Re: NMFS comments on Columbia Generating Station National Pollutant Discharge Elimination System (NPDES) Permit No. WA-002515-1 and accompanying Fact Sheet

SUBJECT: Entrainment and Impingement Potential for Salmonids at the
Columbia Generating Station (CGS) Intake Screens

SUBJECT: Columbia Generating Station (CGS) – Intake Screens Assessment and Recommendations for Modifications

Figure 1. - Length-frequency of 0-age fall Chinook salmon collected with fyke nets: a) barge sets and b) shoreline sets (from Dauble et al, 1989)

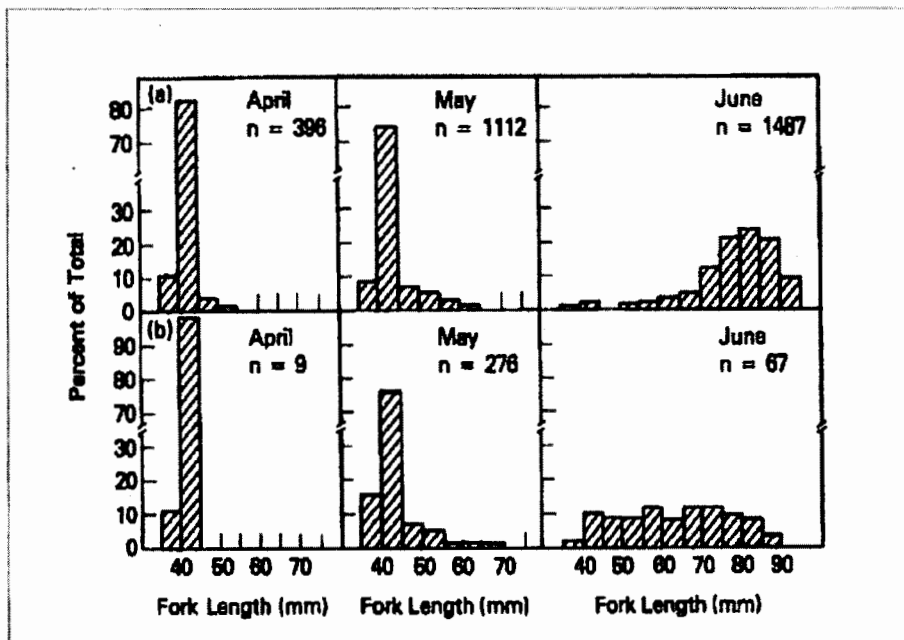
The second is “Spatial Distribution of Juvenile Salmonids in the Hanford Reach, Columbia River”, authored by Dennis D. Dauble, Thomas L. Page and R. William Hanf, Jr., and published in 1989 in Fishery Bulletin, U.S. 87:775-990 (Dauble report). The Dauble report consists of study results showing fish capture from deployment of fyke nets in the Hanford Reach in the vicinity of the CGS intake screens, with the fyke nets set in an array representing the entire cross section of the Columbia River.

salmonids in the early 1990's (Bates and Fuller, 1992) (Beecher, 1993), and later modified by considering the results of a screen evaluation at the Dryden canal (Mueller et al, 1995) (PNNL, 1994). When applied, these criteria generally provide protection to greater than 98% of the juvenile salmon, for fish larger than the button-up fry life, under the coldest water temperatures likely to exist when these fish are present. Generally, Chinook and steelhead fry are not migratory, but are sometimes prone to be swept downstream by freshet flows, and will also move around to forage. Occurrence of either of these events could place fry in the vicinity of the CGS intake screens and vulnerable to entrainment. Zero-age juvenile Chinook and steelhead are actively foraging, moving from shallow waters to deeper waters depending on a number of factors. In a fyke net study conducted in the vicinity of the CGS intake, zero-age fall Chinook salmon occurred primarily in shoreline areas of reduced current velocity (see Figure 1), but were present throughout the river cross section during their early rearing and outmigration period (Dauble et al, 1989). These fish are susceptible to entrainment through the CGS intake screens.
